Re: Indian Point Unit No. 2
Docket No. 50-247

Subject : Supplemental Information Regarding Resolution of Unresolved
Safety Issue A-46, "Seismic Qualification of Equipment in Operating
Plants," (TAC No. M69453)

SUPPLEMENTAL INFORMATION REGARDING
RESOLUTION OF UNRESOLVED SAFETY ISSUE A-46

FIGURE II.6

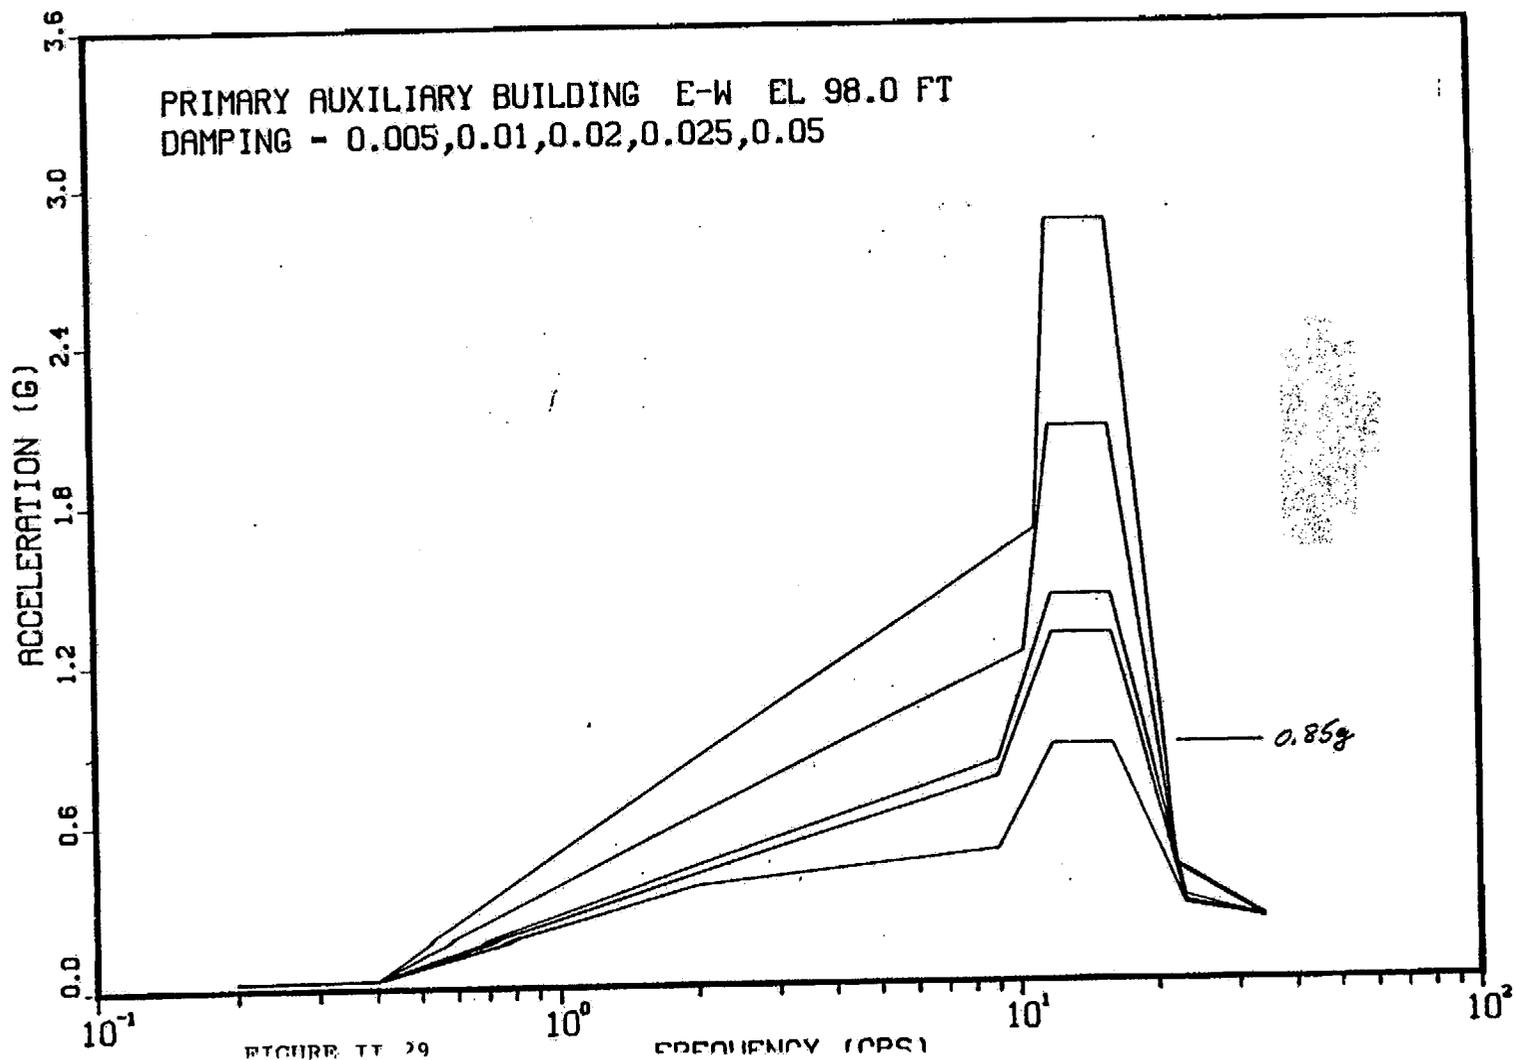
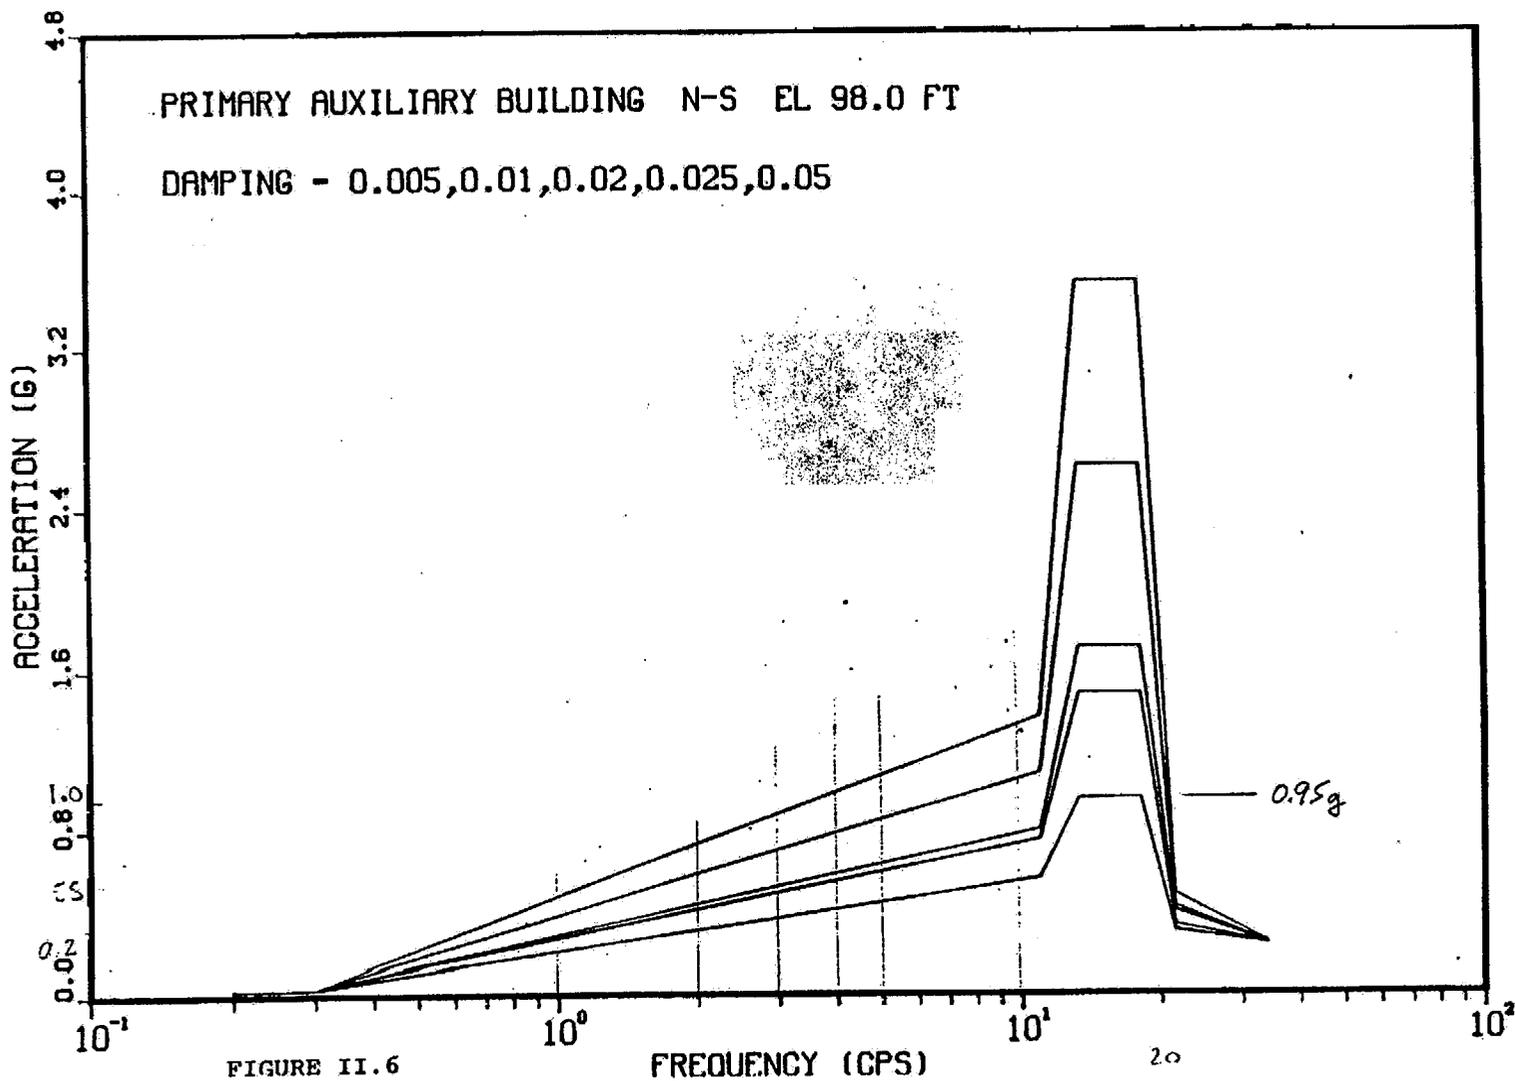
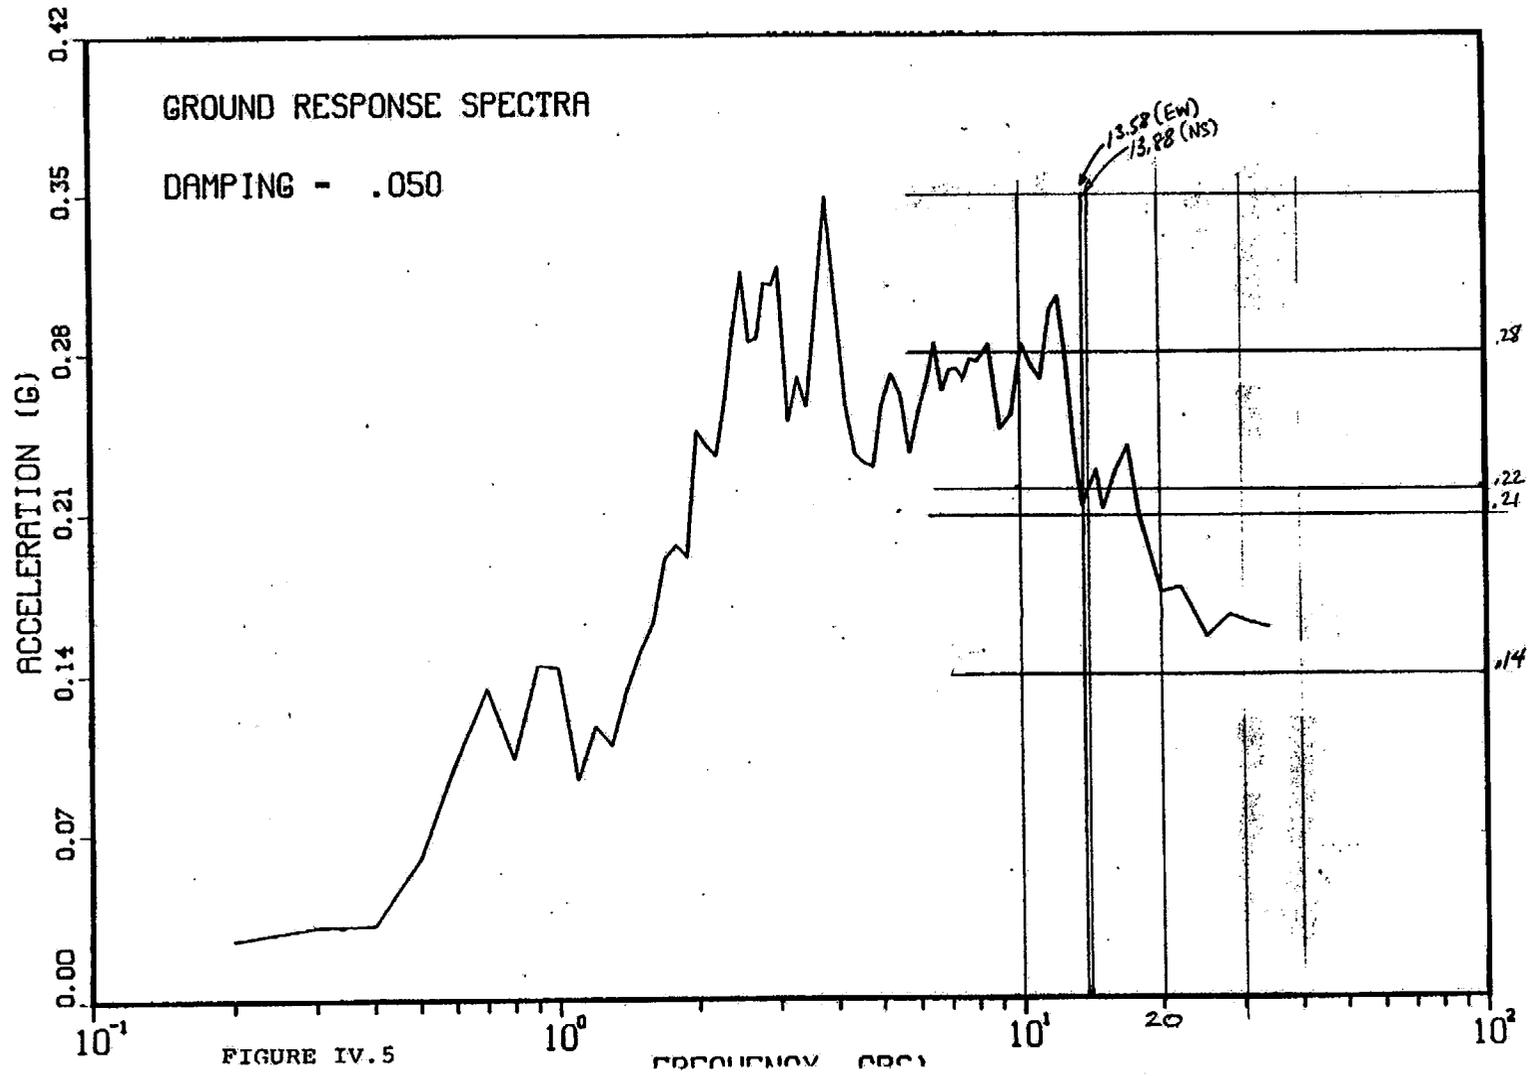
NRC calculations of the amplification factor between the free-field ground response spectrum (Indian Point Unit 2 Housner Spectrum with a peak ground acceleration of 0.15g, 5% of critical damping) and the Primary Auxiliary Building in-structure response spectrum for elevation 98 feet (5% of critical damping, as shown in the figure on page 4 of your response to the NRC request for additional information) result in amplification factors higher than 1.5 and as high as 6.33 in the frequency range above 8 Hertz. In light of this justify your use of Method A.1.

Reference (a) also provides response spectra plotted for the free-field time history used in the ISRS generation. Figure IV.5 from Reference (a), attached, is the 5% damped spectrum of the input time history. The spectral acceleration is 0.215g at 13.58 Hz and 0.22g at 13.88 Hz.

Dividing the peak spectral accelerations of the design ISRS for elevation 98 feet of the PAB by the mean value of the ratios from Reference (b), 3.77, results in estimated realistic, median-centered peak spectral accelerations of 0.23g and 0.25g for the East-West and North-South directions, respectively. The ratios of these values to the corresponding spectral accelerations of the input free field time history (0.215g and 0.22g) are 1.07 and 1.14, respectively. This indicates that if realistic, median-centered ISRS were developed for elevation 98 feet of the PAB, the amplification would be about 1.5, thus justifying use of Method A.1 at this location.

Figure 1.11-2
Fifteen Percent of Gravity
Response Spectra

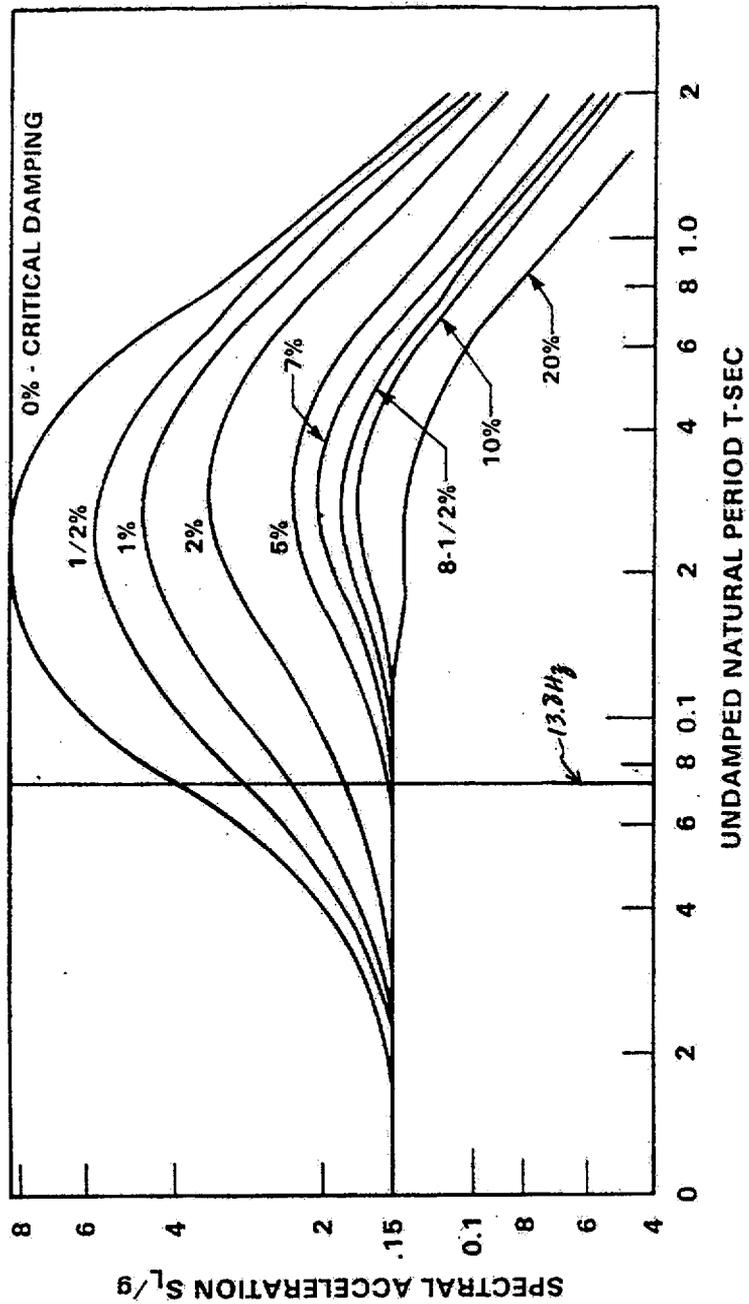
If you are relying on the acceleration values of the response spectrum of the time history actually used to generate the Primary Auxiliary Building in-structure response spectra being higher than those of the Housner Input Design Spectrum as a factor adding to the conservatism of the in-structure response spectra, provide a comparison of these two spectra for 5% of critical damping.

The response spectrum of the time history actually used to generate the Primary Auxiliary Building in-structure response spectra is shown following the response to question 1. For comparison, the Housner Design Response Spectrum (FSAR Figure 1.11-2) is attached. For comparison, the spectral acceleration values for 5% of critical damping at the primary N-S building response frequency of 13.8 Hertz are 0.22g and 0.155g, respectively.
